**GRU DNAPL Team Comments to Tetra Tech Work Plan for for
Floridan Aquifer Extraction Well FW-32BE
October 21, 2011**

This document presents comments from the GRU DNAPL on the *Upper Floridan Aquifer Extraction Well FW-32BE Installation Work Plan, Koppers Inc. Site, Gainesville, Florida* submitted to EPA by Tetra Tech GEO, Louisville September 23, 2011.

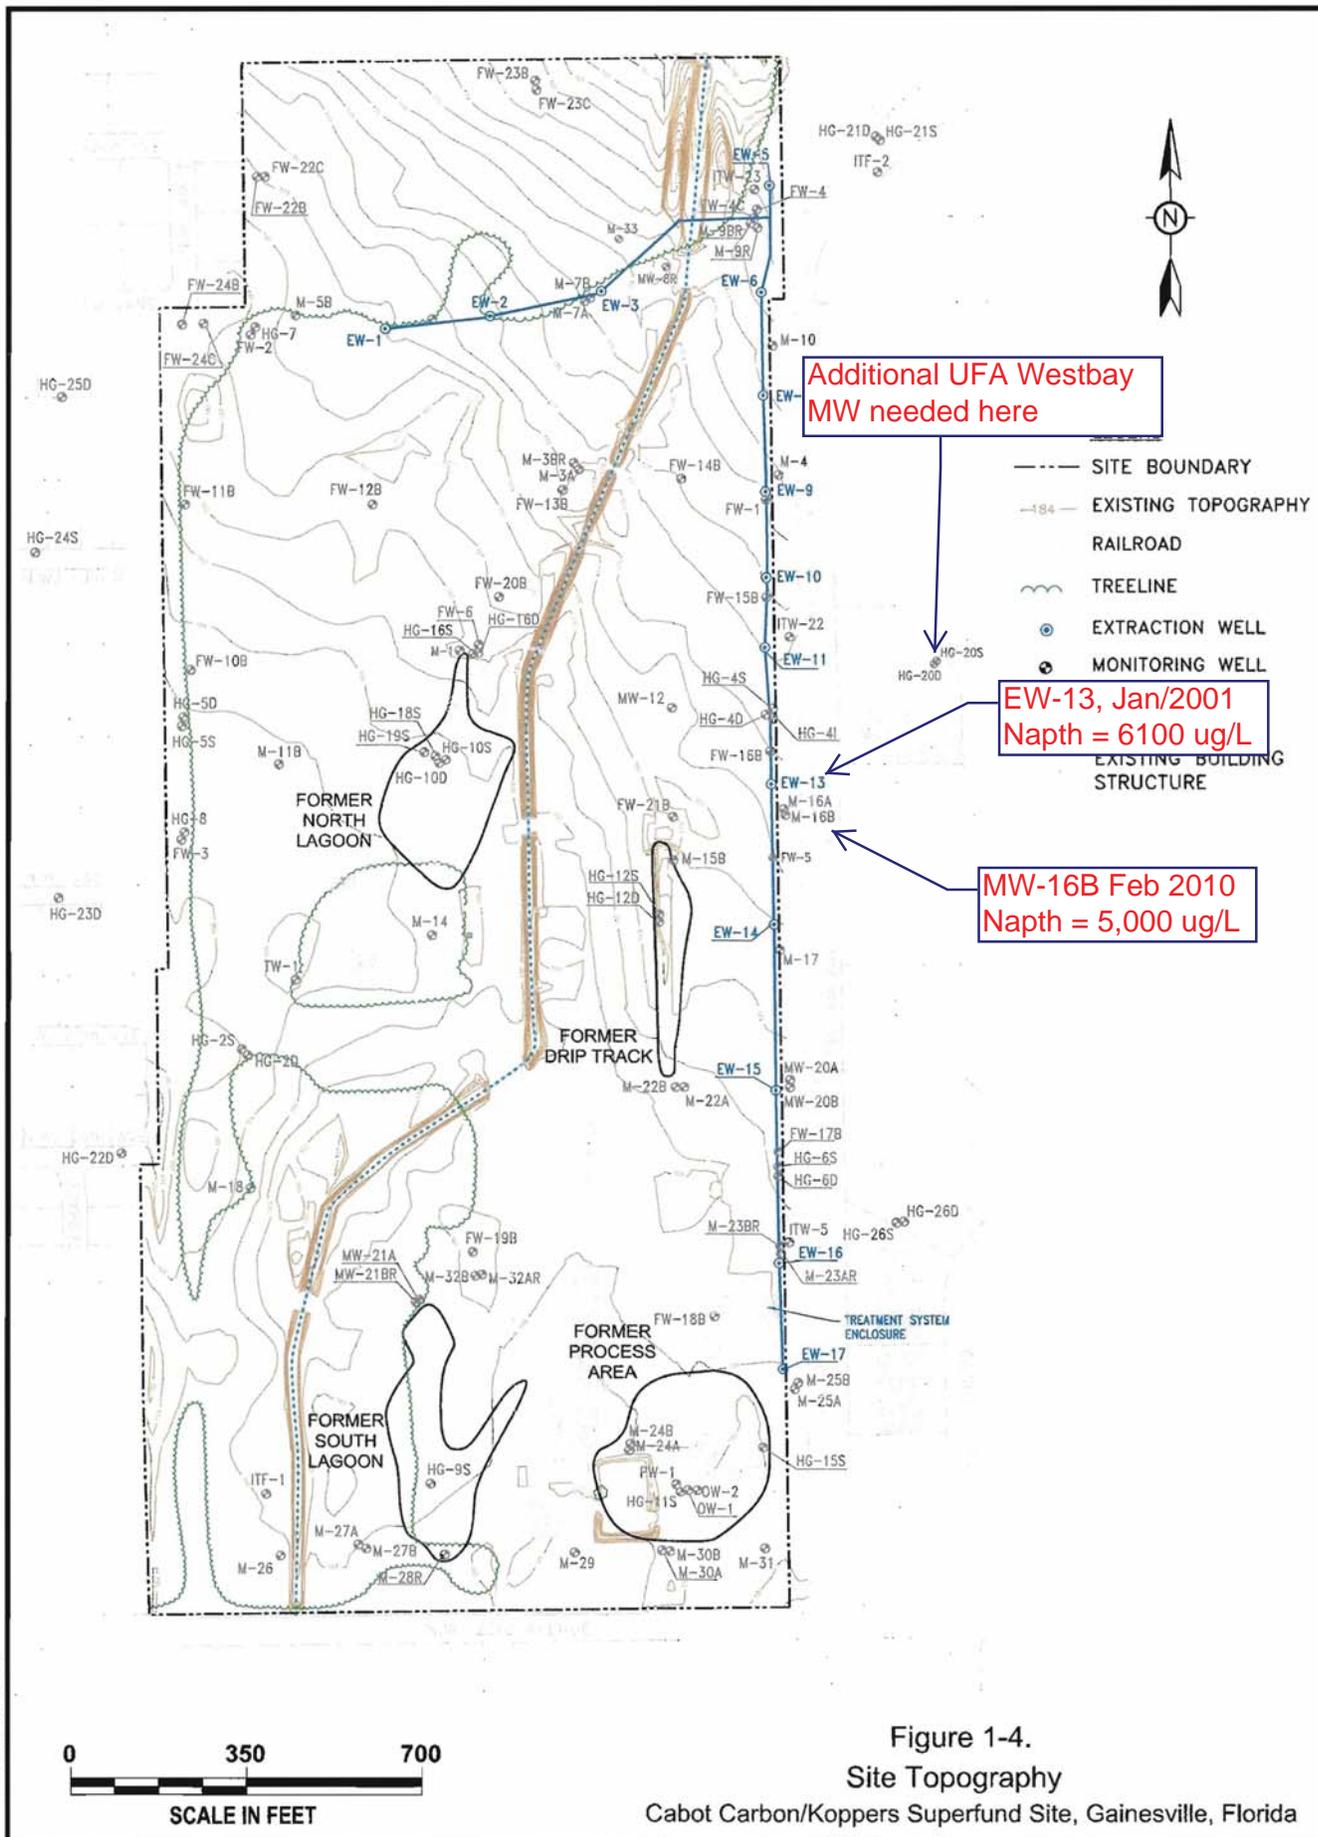
In our comments submitted to EPA on 16 December 2009 re the Draft FS, and in our comments to the Proposed Plan (October 2010) ACEPD and GRU called for the installation of UFA monitoring wells off-site immediately downgradient of FW-16B, and FW-31BE to ensure that the extraction wells are successfully preventing off-site plume migration. Tetra Tech indicates that the objective of installing FW-32BE “upgradient of FW-16B is to pull the plume back on Site and not allow it to spread further downgradient”. Therefore the need for an additional monitoring well on the east side of the Railroad tracks is now clear and a monitoring well should be installed to determine the effectiveness of this remedial goal. We recommend that the Work Plan be revised to include a new Westbay monitoring well in the UFA at the location of the well cluster HG20S/D (see attached Figure) before the aquifer test so that its hydraulic and water quality response may be recorded and aquifer parameters be determined for this part of the UFA.

Additional UFA Westbay
MW needed here

EW-13, Jan/2001
Naph = 6100 ug/L

MW-16B Feb 2010
Naph = 5,000 ug/L
